**NEW RIVER CHANNEL IMPROVEMENT
GRAND AVENUE TO SKUNK CREEK
ADDENDUM NO.1**

**FCD Contract 98-24
Assignment No. 4**

March 6, 2001

ADDENDUM #1 - FIGURE 1

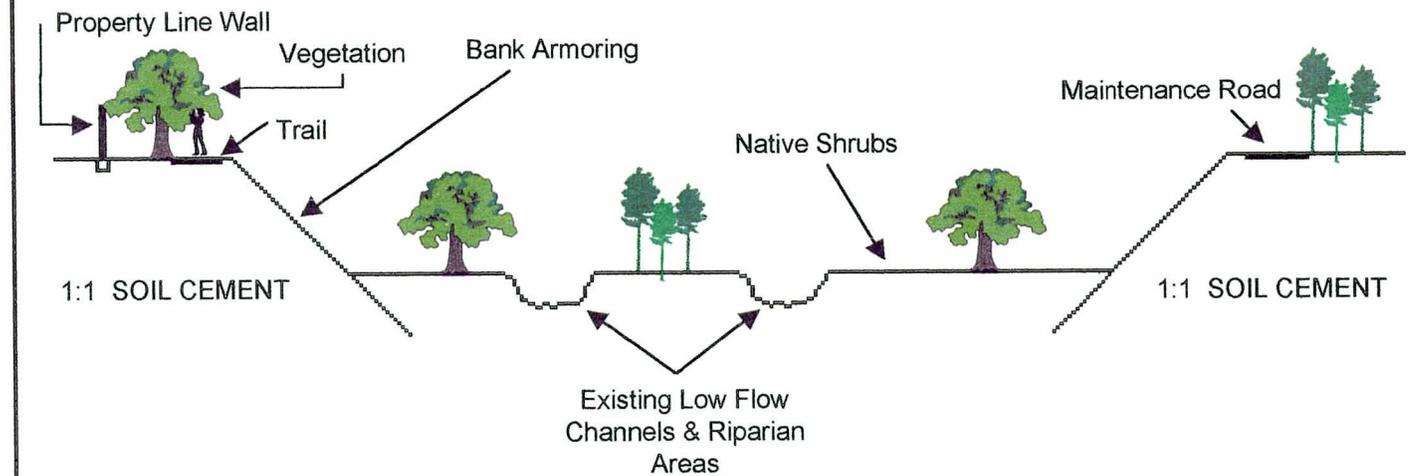
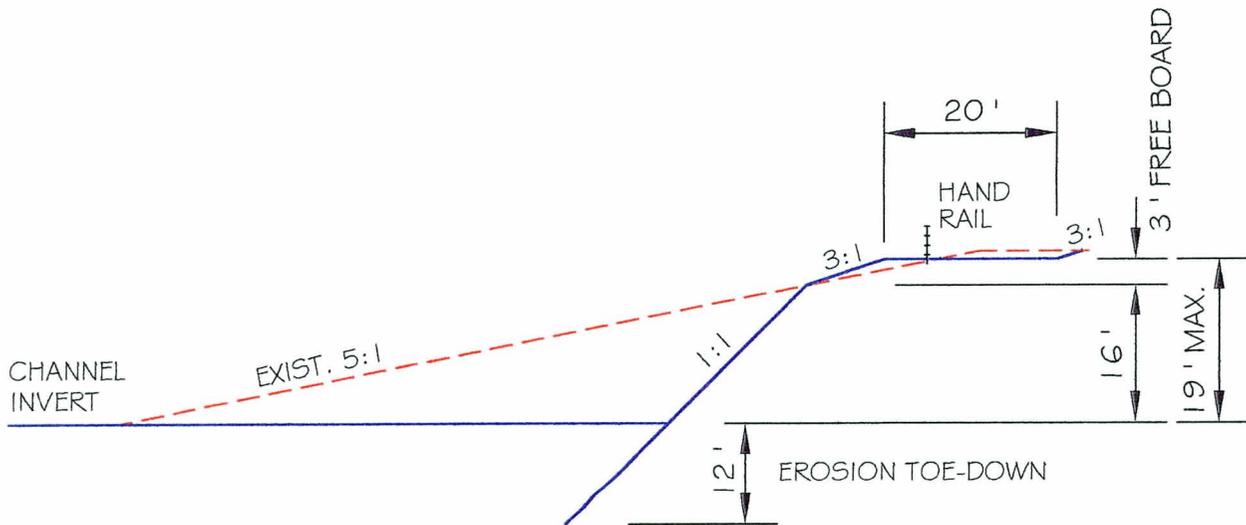
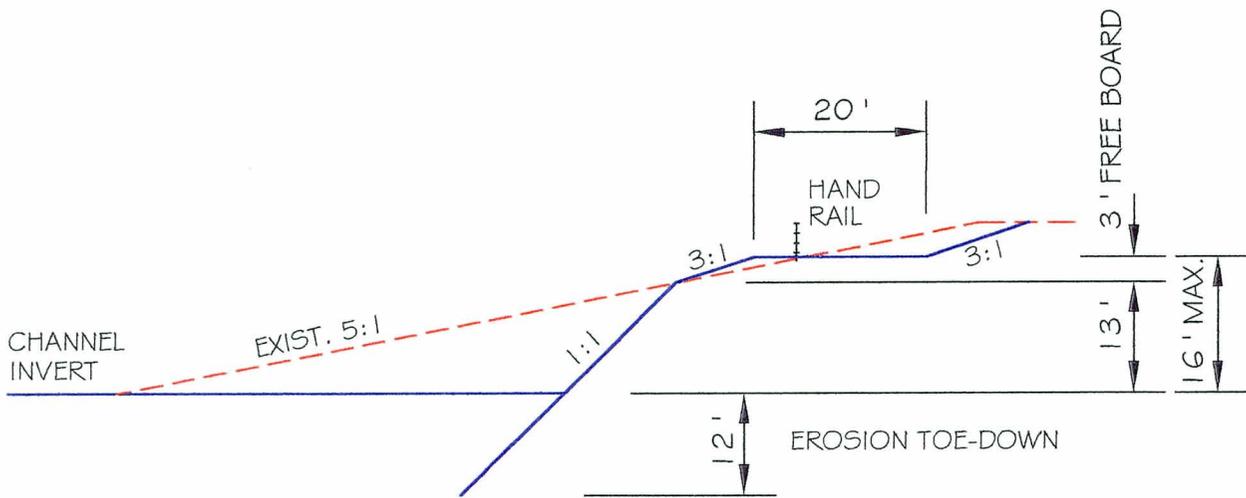
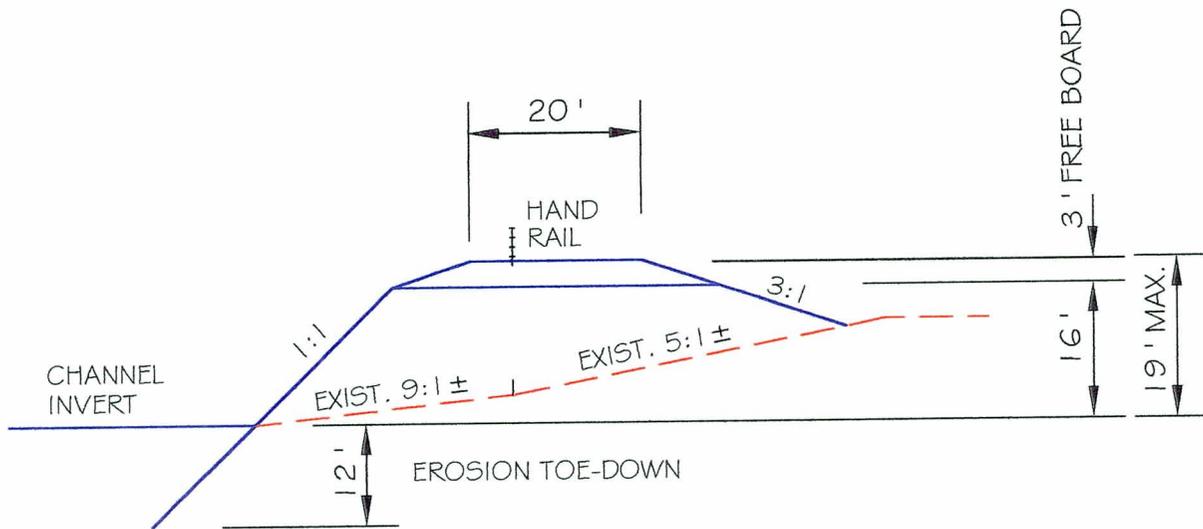
Another variation desired included narrowing the bank armoring options to either soil-cement or gabions. Although the stable side slopes for either option can vary from 0.5:1 to 2:1 depending on soil conditions, required conveyance area, desired aesthetics and other factors, a reasonable slope of 1:1 was chosen for both options in this analysis. A second factor to be considered, because the existing banks have a nominal 5:1 slope, is the location to place the slope to obtain either balanced earthwork or relocate the toe outward to obtain additional channel capacity. Although such a detailed analysis is beyond the scope of this assignment, a preliminary review shows the following advantages to relocating the toe outward:

- Additional channel capacity reduces the height of soil cement or gabions required.
- Additional capacity should also reduce velocity, resulting scour depth and required toe-in depth.

- Moving the toe outward will also allow for a wider trail, which is particularly critical in the area north of Thunderbird Road for neighborhood acceptance.
- A large portion of the soil generated can be used for construction of a levee needed on both the east and west banks between the Freedom Care Center and the existing soil-cement bank protection north of Grand Avenue. The balance could be placed behind the levee to prevent ponding.

ADDENDUM #1 - FIGURE 2

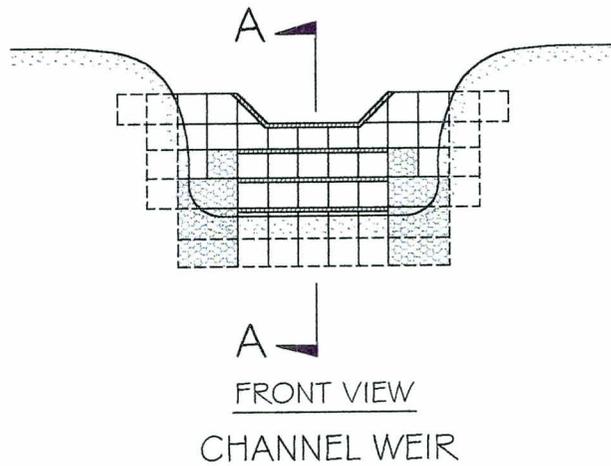
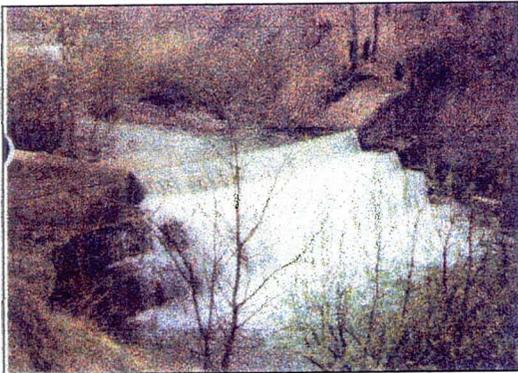
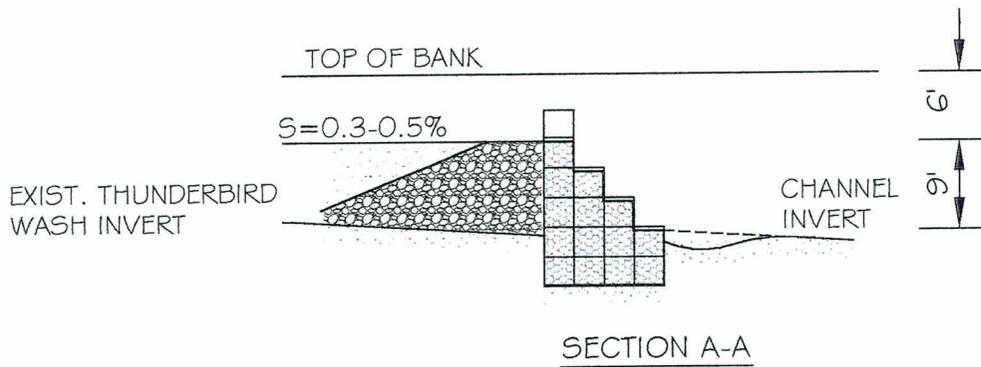
As shown on the report Figure 7 “Public vs. Private Ownership Map”, the channel north of Grand Avenue, which connects to existing soil cement bank lining, northward toward the Freedom Care Center is subject to inundation from the 100-year flood. Although some uncontrolled fill has been placed in the area south of the Freedom Care Center, natural ground is sufficiently low enough to require construction of a levee for flood protection. A 2000 foot levee is shown at this location on Figure 8. Since the completion of the original New River CAR, an apartment complex has been constructed on the east New River bank, south of Thunderbird Road, which included some bank protection. Visual observation of the project indicated that the rip-rap placed extended from the top of the bank to approximately 2/3 down the slope. It was not apparent if the rip-rap extended further or included a toe-in. It may be possible to incorporate this work into future improvements if a review of the design and construction documents show it to meet the standard design criteria.

ADDENDUM #1 - FIGURE 3

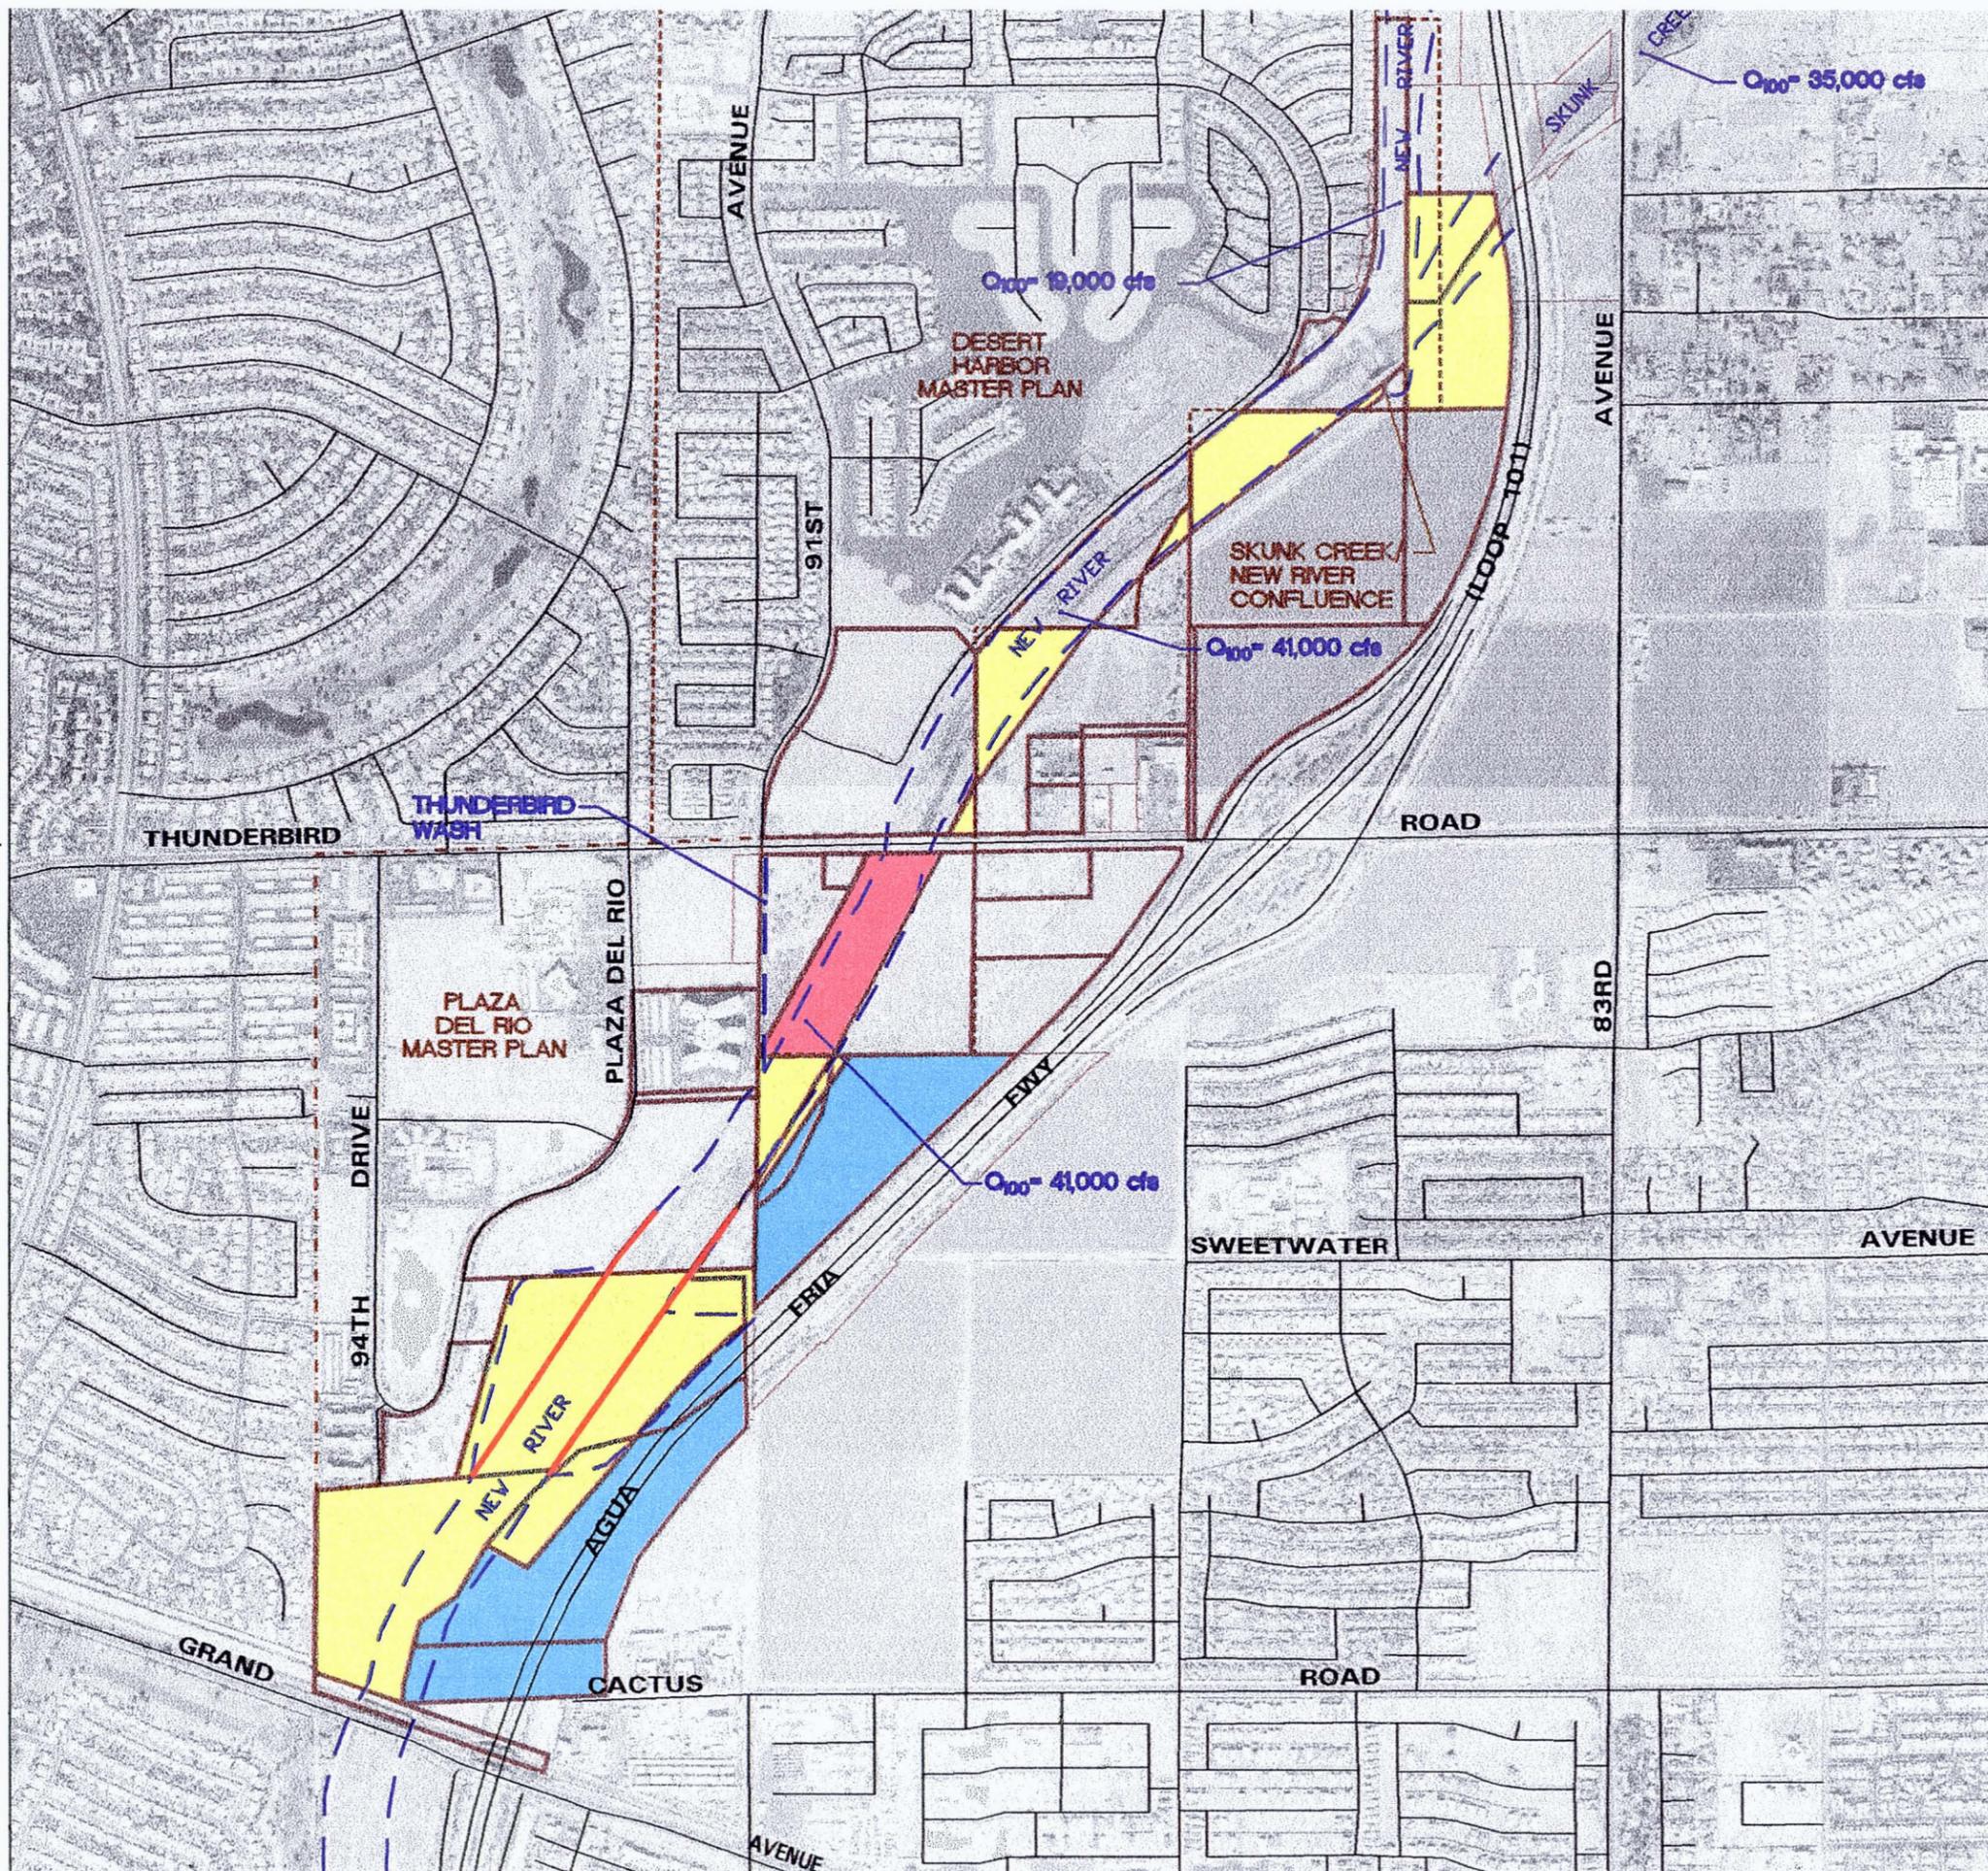
The confluence with several tributary channels including the Thunderbird wash, detention basin outlets from Freedom Care Center, a discharge channel from Sun City and Loop 101 drainage channels will present challenges to design and construction but are not insurmountable. The detention basin and Loop 101 discharges may be direct discharge or may require a flap gate to prevent backflow with higher river flows. The exact design will be determined during final design based on flood elevations versus discharge invert elevations. The Thunderbird wash discharge, however, is envisioned to be an unregulated, direct discharge with a gabion weir. The weir will be required to protect an existing high voltage electric transmission tower, restore the wash invert to a higher elevation, and prevent future erosion in the discharge vicinity. A concept with cross-section and front view is provided in Exhibit 3.
